# UNITED STATES PATENT AND TRADEMARK OFFICE

APPLICATION NO.	FILING DATE	FIRST NAMED INVENTOR	ATTORNEY DOCKET NO.	CONFIRMATION NO.
10/814,586	04/01/2004	Chris W. Cicenas	09086.0037-00	5862

This is the first Office action for the serial number 10/814,586, METHODS AND APPARATUSES FOR ASSEMBLING RAILINGS, filed on 4/1/04.

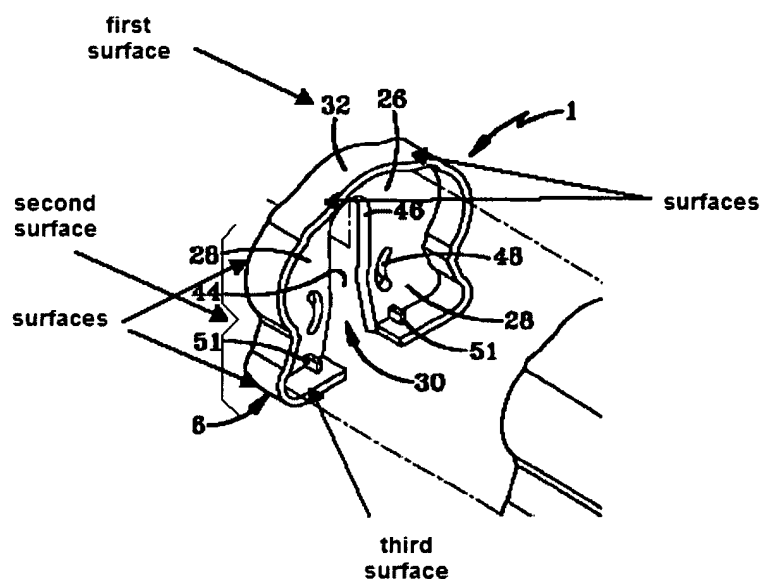
Claims 80-96, 99 and 104 are rejected under 35 U.S.C. 102(b) as being anticipated by US Patent # 5,788,224 to Platt.

Patt teaches a rail assembly comprising a rail (2), a post (3) and a bracket (1) for mounting the rail to the post. The bracket comprises a post surface (28) at least a portion of which is configured to abut a mounting surface of the post, at least two surfaces (32 and on the side adjacent to element 32) configured to be associated with and not parallel to the post surface of the bracket. A first surface (32) of the at least two surfaces is configured to accommodate the rail mounted to the post in a first configuration and a second surface (on the side adjacent to element 32) of the at least two surfaces is configured to accommodate the rail mounted to the post in a second configuration different from the first configuration. The first configuration of the rail is configured to be mounted to the post at a first angle relative to the mounting surface of the post and in the second configuration of the rail is configured to be mounted at a second angle relative to the mounting surface of the post different from the first angle. Both of the first

configuration and the second configuration of the rail is configured to be in a substantially horizontal orientation. The first surface comprises at least two first surfaces (two surfaces are inclined from the top of element 32). The second surface comprises at least two second surfaces. The assembly further comprises the third surface (located on the bottom of the bracket) configured to be associated with the post surface. See drawing of figure 2 from Platt's invention shown below for clarification:
